SERVICE BULLETIN NO. 177

INSPECTION OF AILERON TORQUE TUBES

MODEL/SERIAL EFFECTIVITY: AG-5B 99998 & 10000 - 10073 (IMMEDIATE INSPECTION)

FIGURE 1

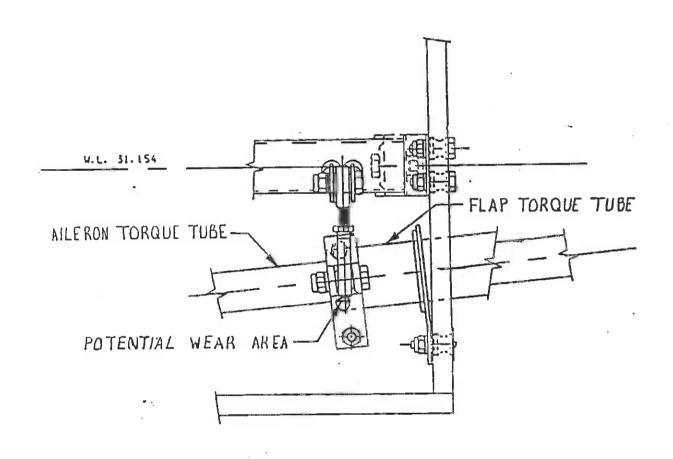
The aileron torque tube assemblies (part no. 5202035-507) in some AG-5B aircraft have been found with excessive wear due to misalignment of the aileron torque tube to the flap torque tube. The wear occurs at the point were the flap torque tube is attached to the flap drive tube under the rear seat of the aircraft.

- Remove rear seat back cushions, fold out rear seat bottom and remove canvas cover.
- 2. Examine the area indicated in Figure 1 for alignment of the two torque tubes and for any signs of flap drive bolt contact and wear. If the inside diameter of the flap torque tube is closer than 0.060 inches from the aileron torque tube or if any signs of bolt contact or wear are found then repair or replacement of the aileron torque tube becomes necessary.

The areas in question should be inspected using the following procedure and if any wear has occurred then the torque tube must be repaired or replaced as outlined in the repair section of this service bulletin.

FIGURE 2

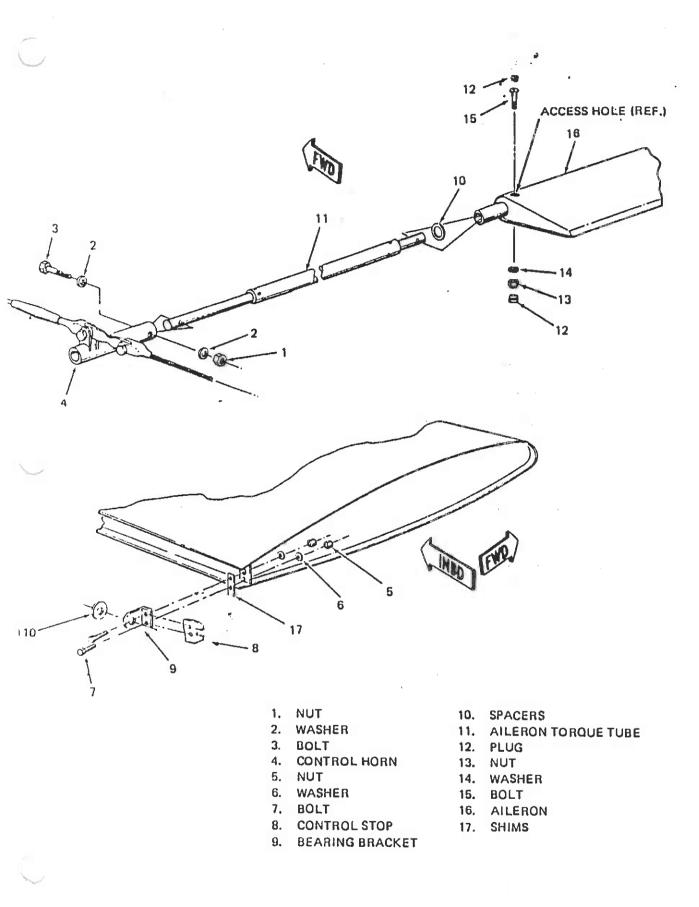
If the inspection of the aileron torque tube reveals any damage then the following procedure must be completed (refer to Figure 2). If the wear on the torque tube is deeper than 0.030 deep then the torque tube can not be repaired and must be replaced.

- Remove wing tip as described in Chapter 57 of AA-5 series Maintenance Manual.
- 2. Remove plugs (12) from inboard end of aileron. Remove the nut (13), washer (14), and bolt (15) from the aileron torque tube.
- 3. Remove nuts (7), washers (6), and bolts (5) from wing and aileron bearing bracket. Remove control

- 4. Remove aileron from the airplane by pulling it outboard.
- 5. Remove nut (1) and washer (2) from bolt which secures control horn to aileron torque tube assembly. Remove bolt (3).

- 6. Pull aileron torque tube assembly outboard and remove it from the aircraft.
- 7. Check the depth of the wear marks on the torque tube. If the marks are more than 0.030 inches deep then the torque tube must be replaced. If the marks are 0.030 inches deep or less then the damage may be smoothed out carefully by using a file and fine grit sandpaper. Caution: do not increase the depth of the damage beyond 0.030 inches during this process or the torque tube will have to be replaced.

- 9. Position torque tube assembly in control horn until the holes align. Secure with bolt (3), washers (2), and nut (1).
- Insure that spacer(10) on inboard end is reinstalled as noted during removal. Slide aileron on to torque tube sleeve until the attach hole aligns. Secure with bolt (15), washer (14), and nut (13). Install plugs (12).

- 11. Insure that shim(s)(17) is installed between the rear spar and the aileron hinge bracket. Position control stop (8) on aft side of aileron hinge bracket (9) and attach them to the aircraft using bolts (7), washers (6), and nuts (5). Connect ground terminal.

- 12. Loosen the aileron and flap bearing bracket bolts inside fuselage and adjust the bearings as required to obtain a minimum clearance between the aileron and flap torque tubes of 0.160 inches.
